DEVELOPMENT ASSESSMENT REPORT

Application No.	DA/2020/0498
Address	209 Albany Road STANMORE NSW 2048
Proposal	Alterations and additions to existing dwelling including garage with studio above at the rear of the site.
Date of Lodgement	01 July 2020
Applicant	Innovac Dyer Architects
Owner	Mr Andrew T Male Mr Paul R Giles
Number of Submissions	No submissions
Value of works	\$41,500.00
Reason for determination at Planning Panel	Clause 4.6 variation exceeds 10%
Main Issues	<ul style="list-style-type: none"> • Non-compliance with Clause 4.4 floor space ratio • Bulk & Scale • Built form and design • Loft Structure over garage • Heritage Conservation
Recommendation	Refusal
Attachment A	Without Prejudice Draft Conditions of Consent (if not refused)
Attachment B	Plans of proposed development
Attachment C	Clause 4.6 Exception to Development Standards

Figure 1: Zoning map

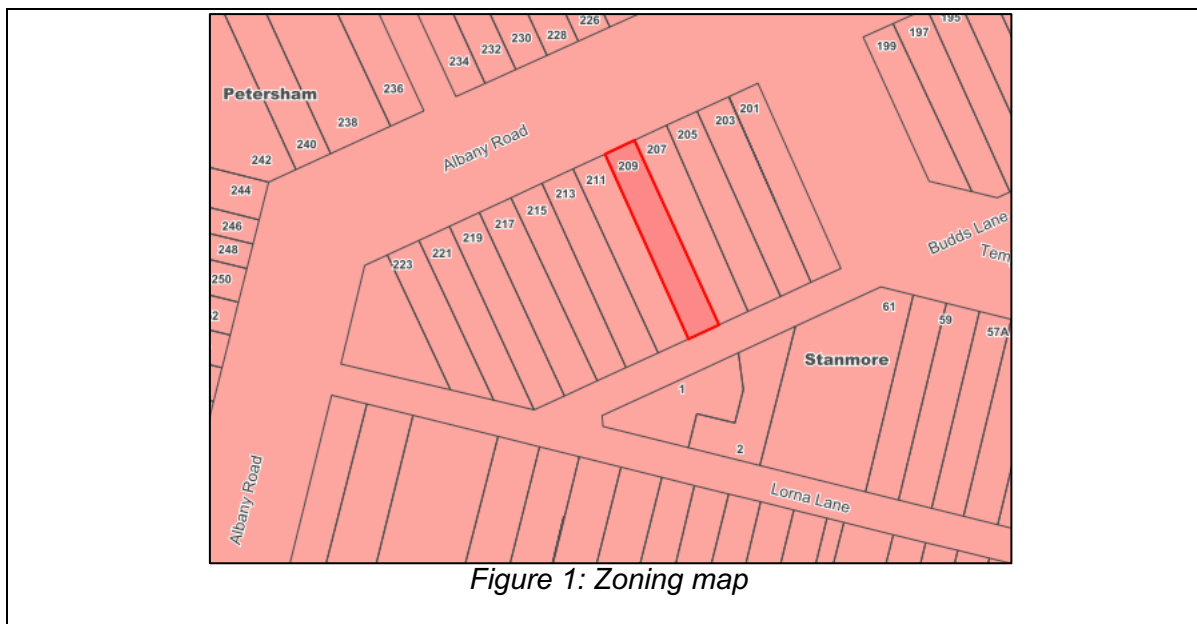
The land is zoned R2 Low Density Residential as shown in the figure below.

Scale: 1:50 @A3
drawn: B. Dyer, B. Arch
date: 8th June 2020
DA7A
DWG NO

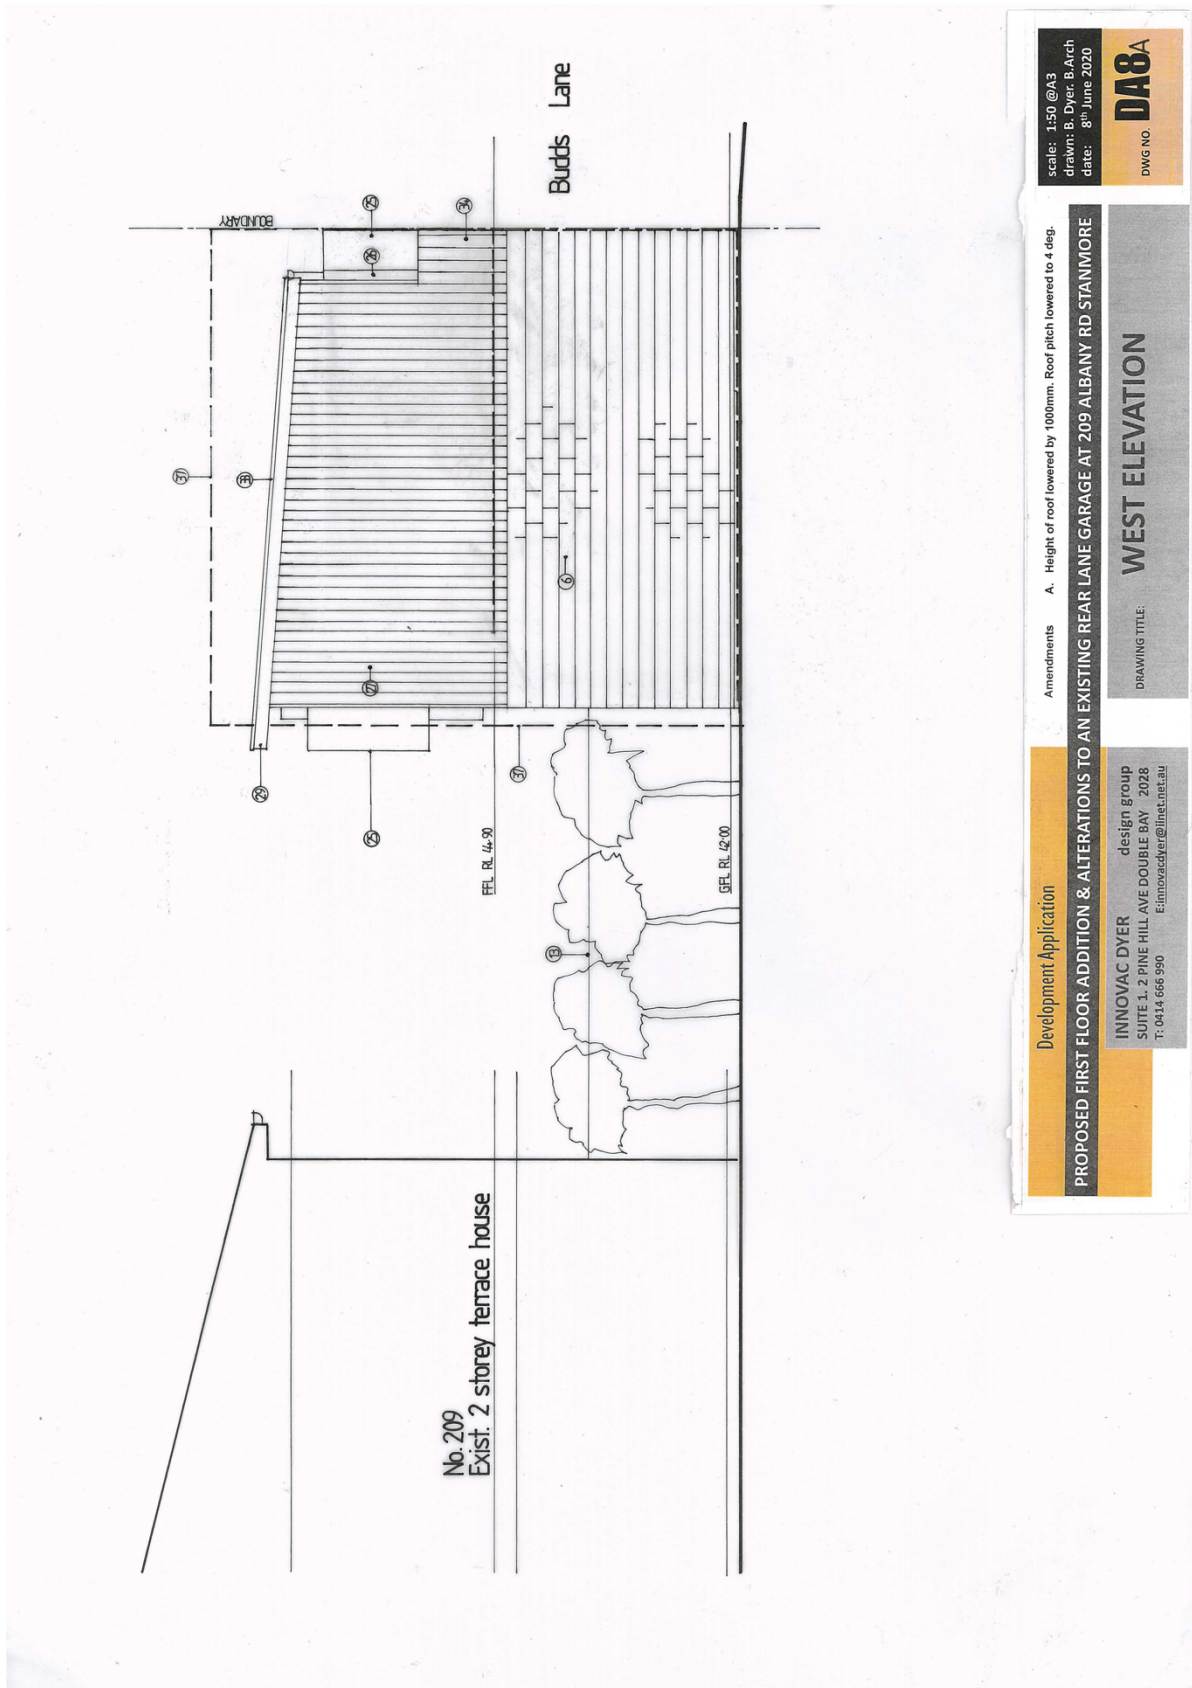
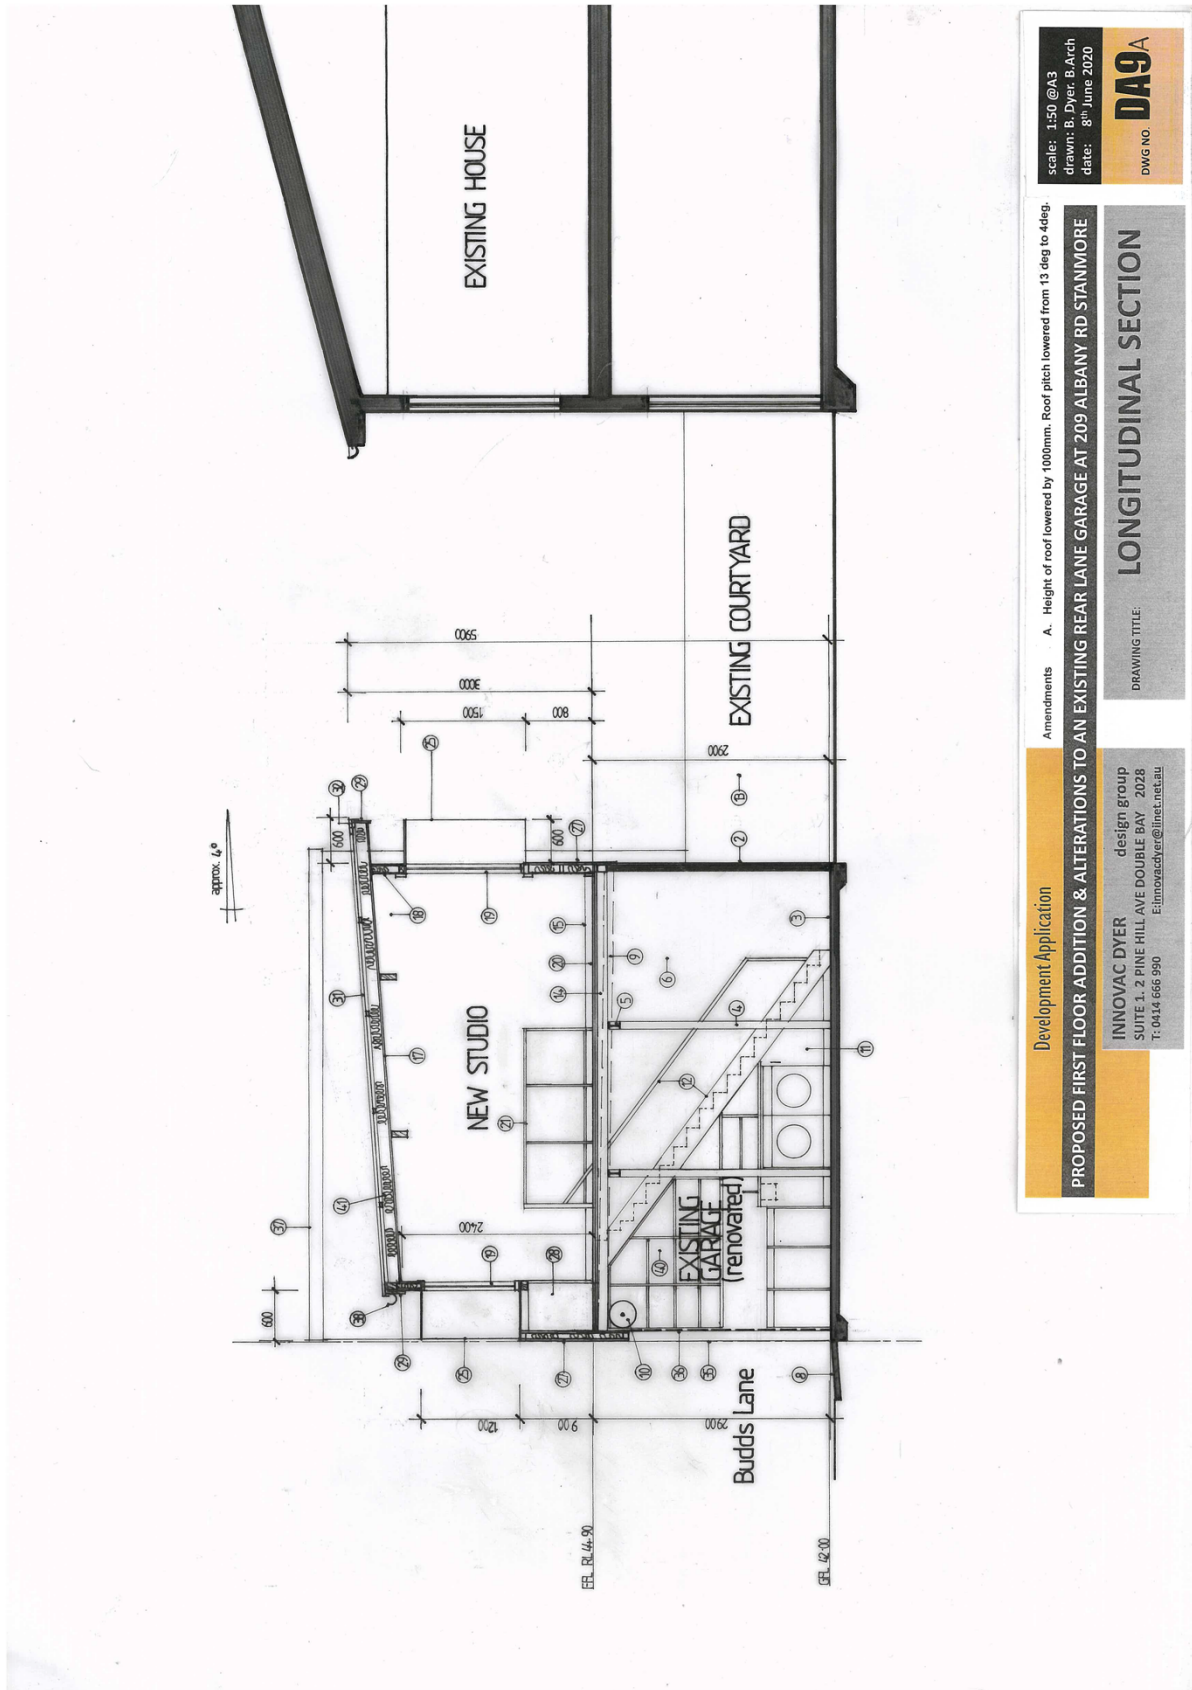
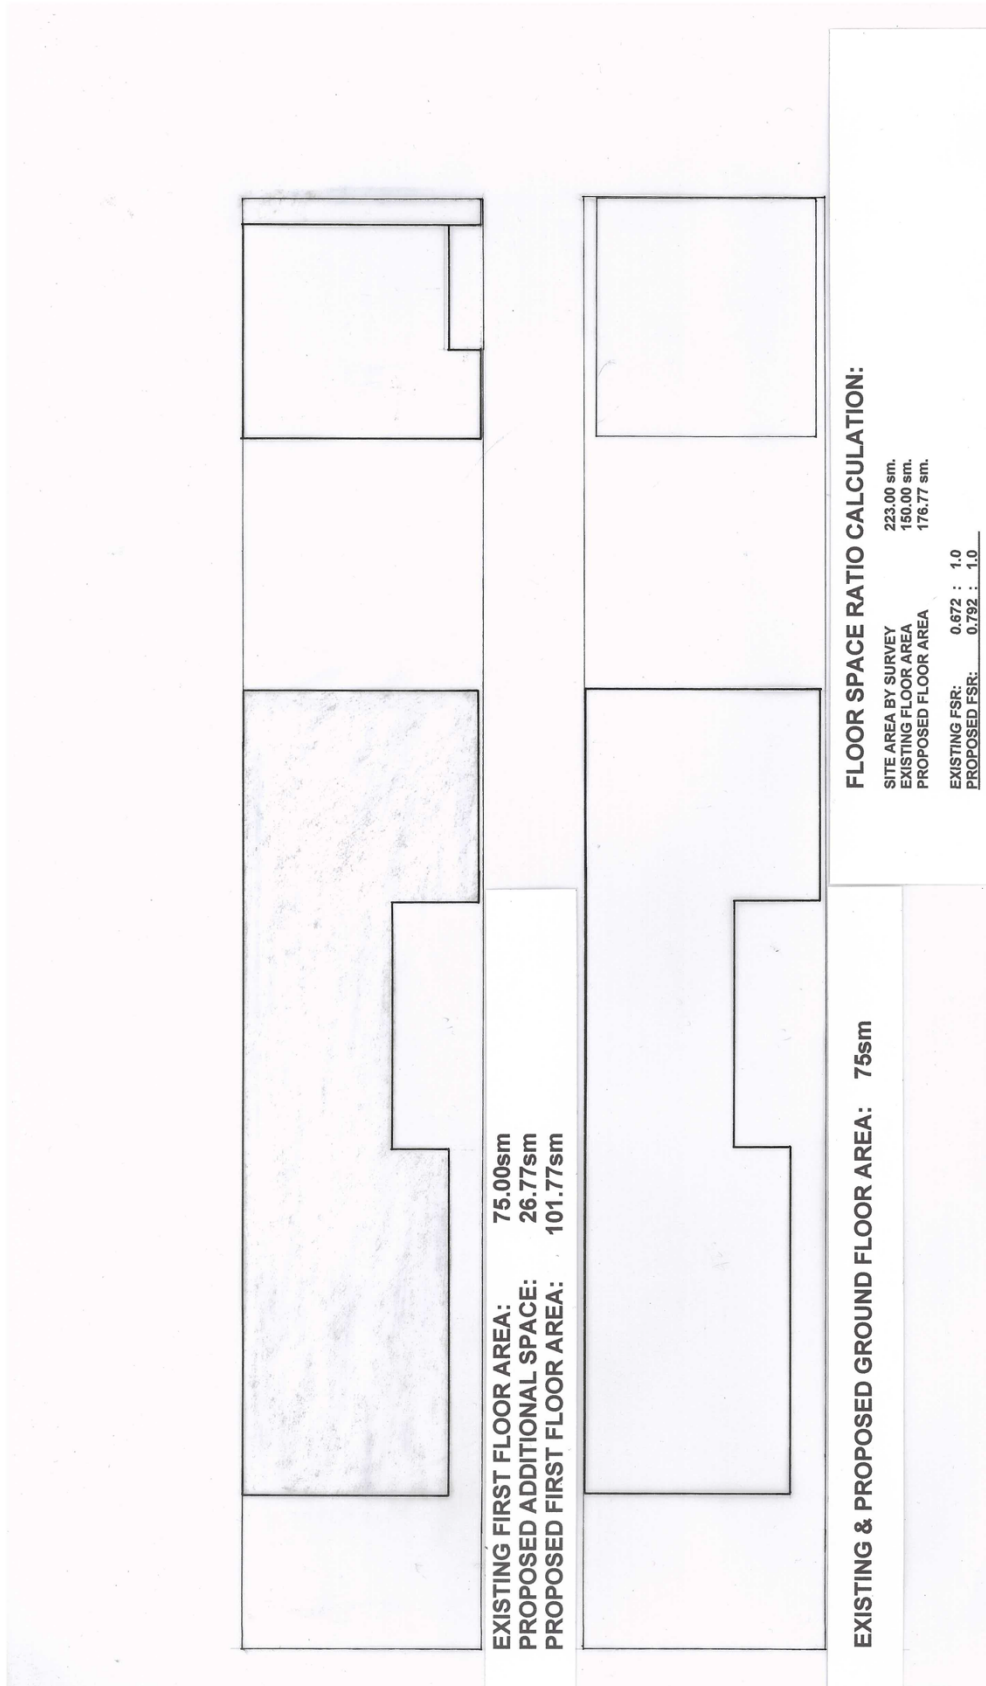
Amendments A. Height of roof lowered by 1000mm. Roof pitch lowered to 4 deg.
PROPOSED FIRST FLOOR ADDITION & ALTERATIONS TO AN EXISTING REAR LANE GARAGE AT 209 ALBANY RD STANMORE
DRAWING TITLE: **EAST ELEVATION**
